**Re:     Permissive Change Request**
Model Name:        BL871E2-HI
FCC ID:        RFR-BL871
IC:        23249-BL871

Identifier Marking for OEM Bluetooth Module BL871E2-HI,

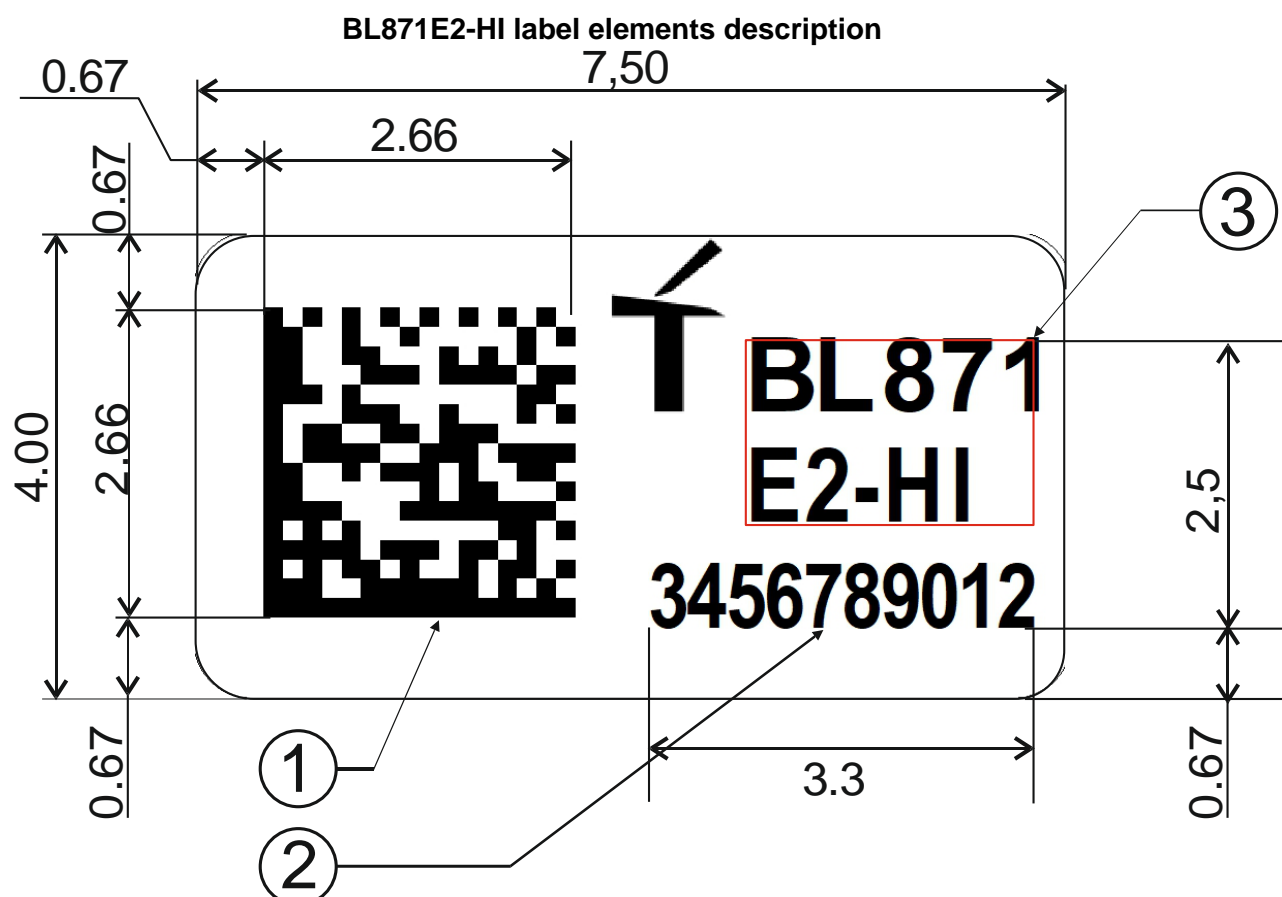
KDB784748 D01 §2.2 defines that it should be possible to print the FCC ID readable without magnifying glasses on the label. The minimum readable size is given with size of 4-6 points. Otherwise the Module manufacturer should ask the FCC tor the permission to publish the FCC ID in the user manual. The following pictures show some attempts to place the FCC ID on the label.

Attempt 1: FCC ID in 4points

Attempt 2: FCC ID in 2points

2points is not readable without magnifying glasses, at least not for me.

If the requested permission was granted by the FCC, the device label specification would be

1) Barcode type 2D datamatrix, ECC200 containing serial number
2) Module Serial number clear writing  font Arial 2pt
3) Module Model/Commercial name font Arial 2.5pt
